UNITED STATES  
NUCLEAR REGULATORY COMMISSION  
WASHINGTON, D. C. 20555

SUBJECT: SEATTLE UNIVERSITY, NUCLEAR CRITICALITY SAFETY REVIEW  
FOR LICENSE RENEWAL 70-600

Nuclear Criticality Safety

SUBCRITICAL CORE ASSEMBLY

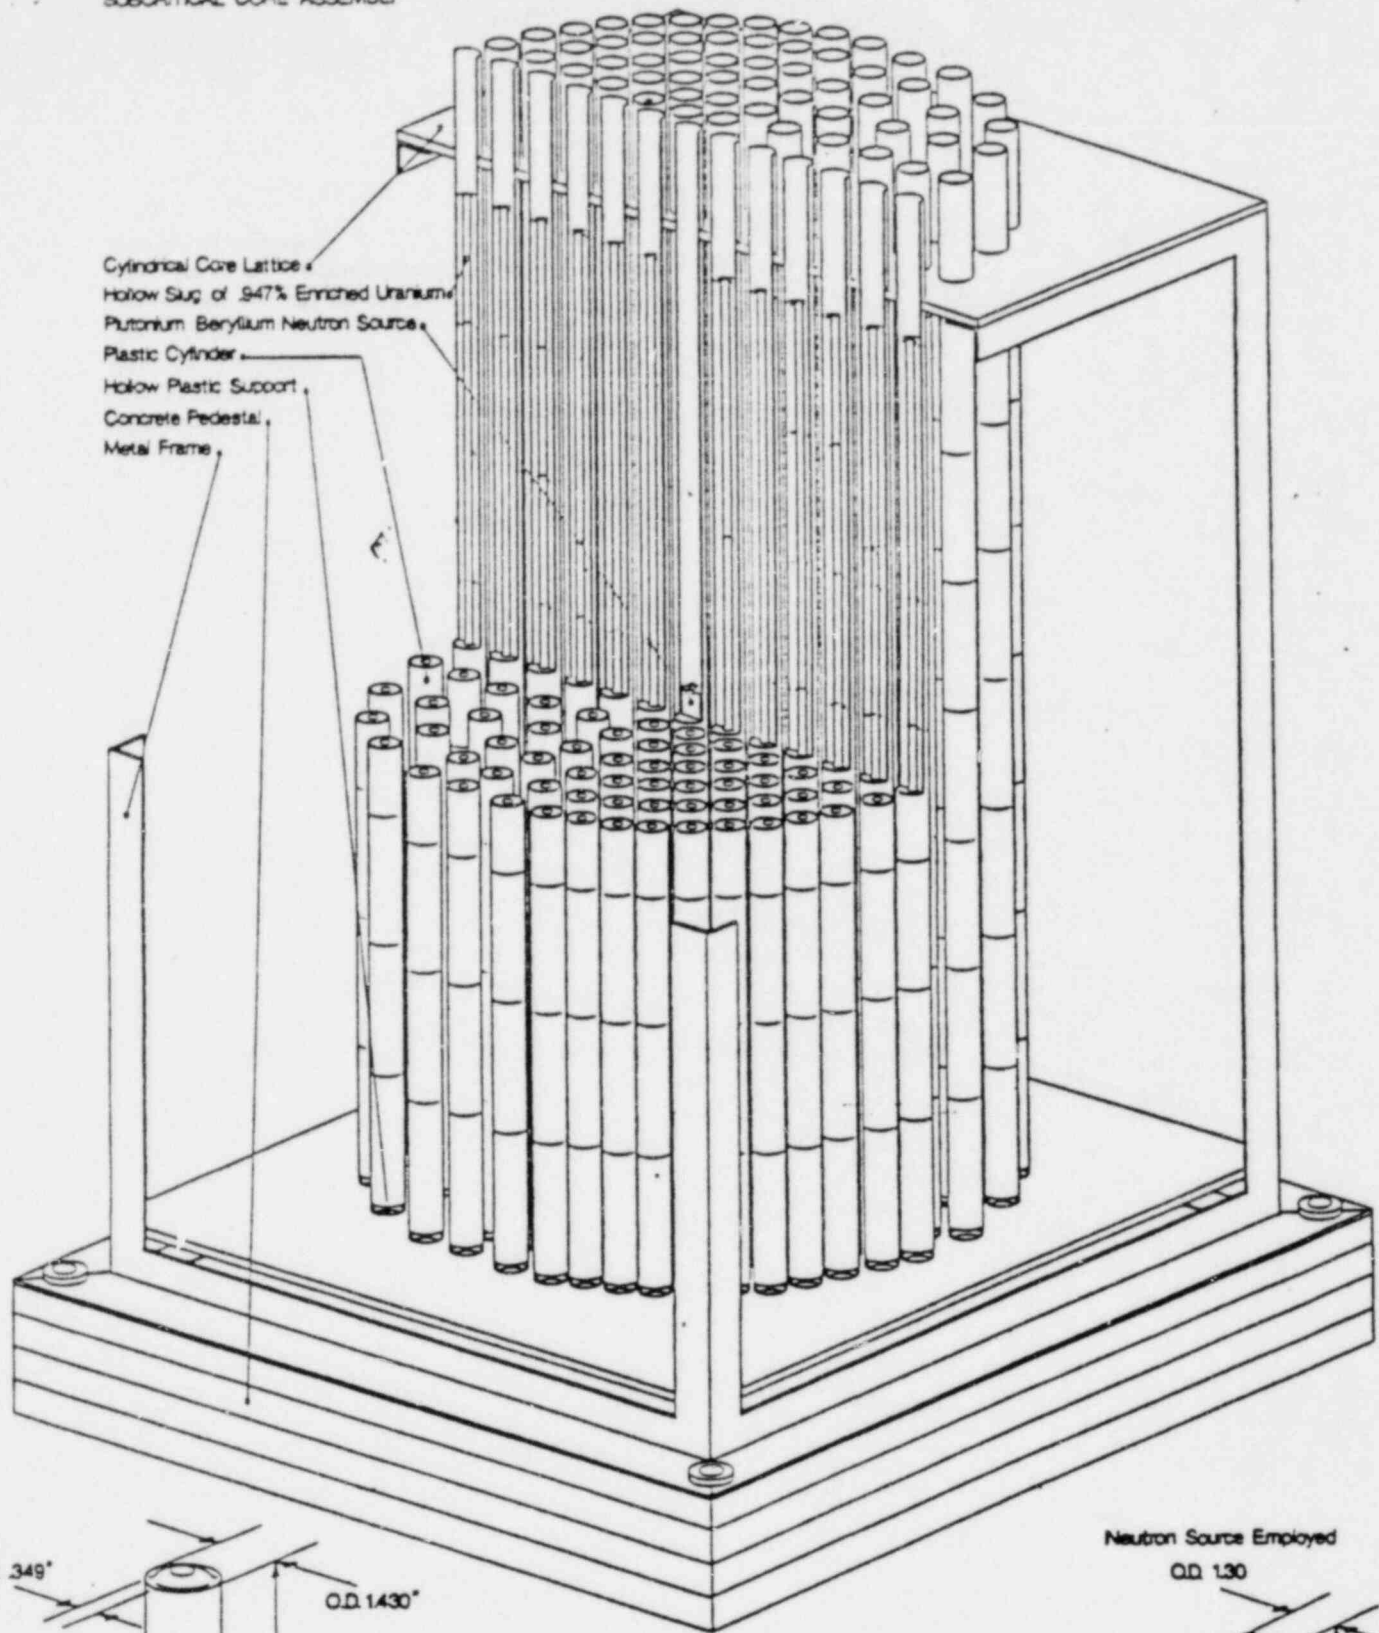
The subcritical assembly is located in a concrete pool on a concrete pedestal. Seven slugs are loaded into a plastic cylinder. The cylinders are positioned by spacer grids above and below the fuel. A total of 896 slugs can be loaded into the plastic cylinders. The subcritical assembly is shown in the attached Seattle University drawing. When experiments are not being performed, water is drained from the pool.

The combination of U-235 and one Pu source is subcritical for all foreseeable water-fuel mixtures. This has been independently confirmed by the staff by plotting data in DP-1014<sup>1</sup> and limited data in HW-65552.<sup>2</sup> In addition, Hans Toffer, UNS Nuclear Industries, confirmed by phone on July 20, 1982, that the critical mass is 9,150 pounds per HW-70233. Only one Pu source is used in the subcritical assembly.
